## ***Interactive comment on “Spatial variability in channel and slope morphology within the Ardennes Massif, and its link with tectonics” by N. Sougnez and V. Vanacker***

**N. Sougnez and V. Vanacker**

Received and published: 4 January 2011

Fig. 1. Annex 1 : Dendrogram

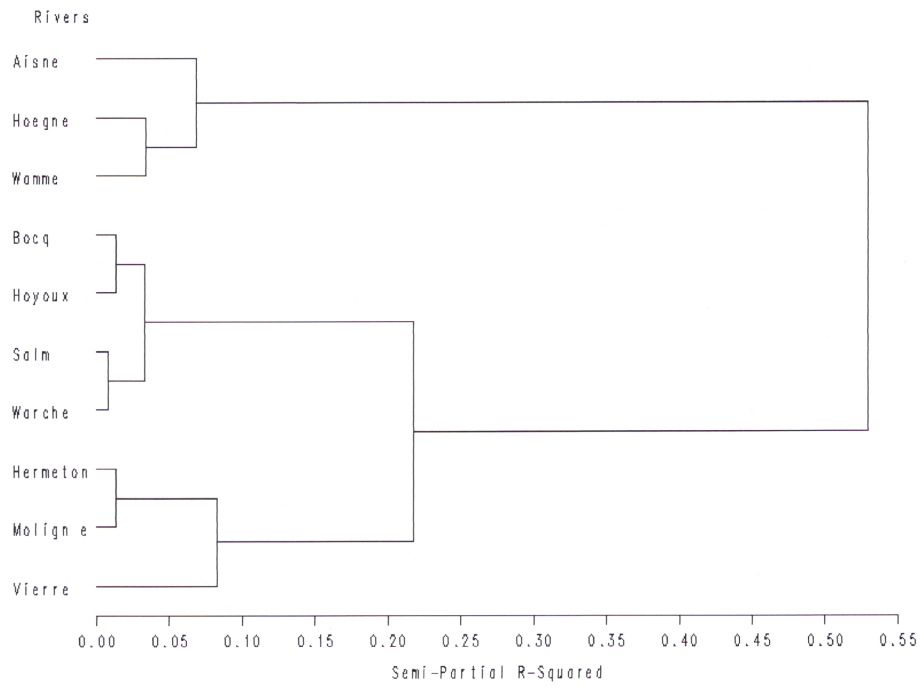
6991,7: "K-means cluster analysis" – This would be a good location to state the total number of observations per parameter for your ten catchments. In other words, state the size of your matrix. Consider showing the results of the cluster analysis (dendro-

REPLY: The size of the matrix is [10x5] (observations x parameters). Here follow (Annex 1) the dendrogram given by the Ward classification method. We did not add this graphic as a figure due to the space requirements and the little information it provides, but the figure is available in the online version of HESSD.

Fig. 2. Annex2 : Ksn distribution in AxS space

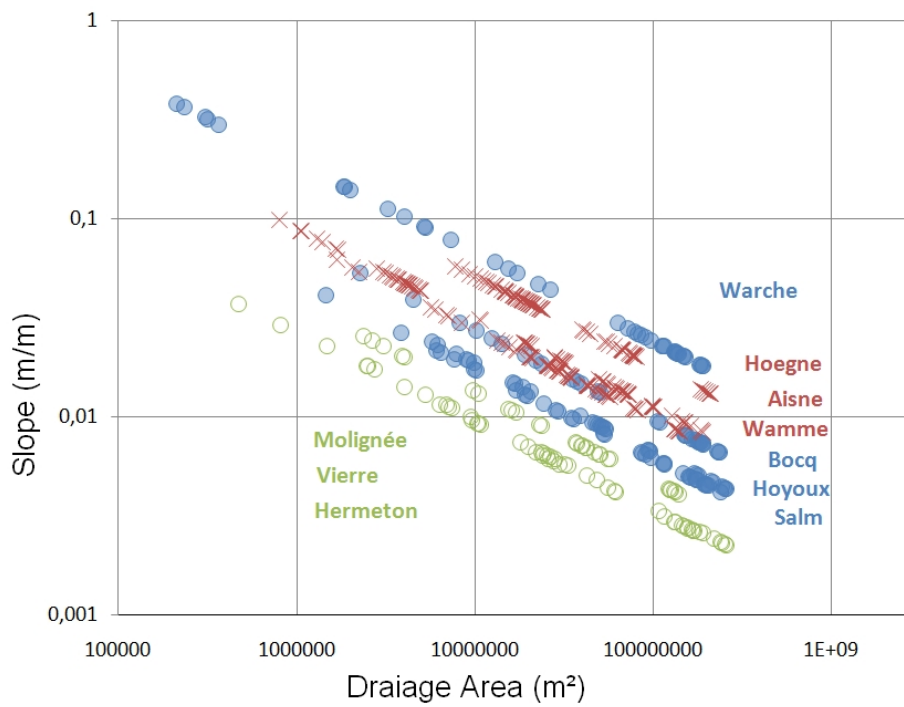
6991,23-24: “a river with low intercept (i.e.  $K_{sn} = 4$ ) can be interpreted as having a greater steepness of its longitudinal profile” – This is odd. Is the normalized steepness index not an indication of the steepness of a longitudinal river profile? Please reconcile.

REPLY: This is correct. Indeed, a relatively high value of  $K_{sn}$  (intercept) can be interpreted in terms of high steepness in the longitudinal profile. We deeply revised the Table 1 according to the reviewer comments and found two problems in our calculation of the  $K_{sn}$  values. The values of  $K_{sn}$  have been corrected in the table as well as the interpretation in the text.

The Bocq and the Warche display a particular shape in the Slope-Area diagram (initial Figure 2). Indeed, in the lowest part of their profile, they present relatively high slopes (black dots around  $10E8$  square meters) that were not taken into account in the calculation of the  $K_{sn}$ . For that reason, we only calculate the  $K_{sn}$  for the upper part of the profile (the part located upstream of the knickpoint), where relatively smooth slopes can be observed. The values of  $K_{sn}$  were recalculated (taking into account the lower part of the catchment) and are respectively 38.5 for the Bocq and 95.5 for the Warche.

The following Figure (annex 2) represents the set of selected rivers in the AS space and with the corrected normalized steepness values (instead of the normal steepness).

We can see the three clusters that have been designed by the k-mean analysis. The first group (Hermeton, Molinee, Vierre ; green circles) have a Normalized Steepness (intercept) lower than the other groups. The second group is characterized by a relatively high value of steepness (Hoegne, Aisne, Wamme ; red crosses). Finally, the

last cluster of rivers (Warche, Bocq, Hoyoux, Salm ; blue dots) is considered as having a medium normalized steepness index, except for the Warche that have the highest steepness of the studied rivers. The fact that the Warche is in the same group than the Bocq, Hoyoux and Salm, is due to the fact that the clustering is multivariate and is based on other river and hillslopes indexes ( $R_{ch}$ ,  $H_o$ ,  $H_I$  and  $SCI$ ).

The steepness value that we discussed in the original manuscript was not the Normalized steepness ( $K_{sn}$ ) value but the Normal Steepness ( $K_s$ ). The latter is known to be highly influenced by the theta value ( $K_s=4$ , and not  $K_{sn}=4$ ). We have adjusted the text of the discussion, and now base our discussion on the normalized steepness values.
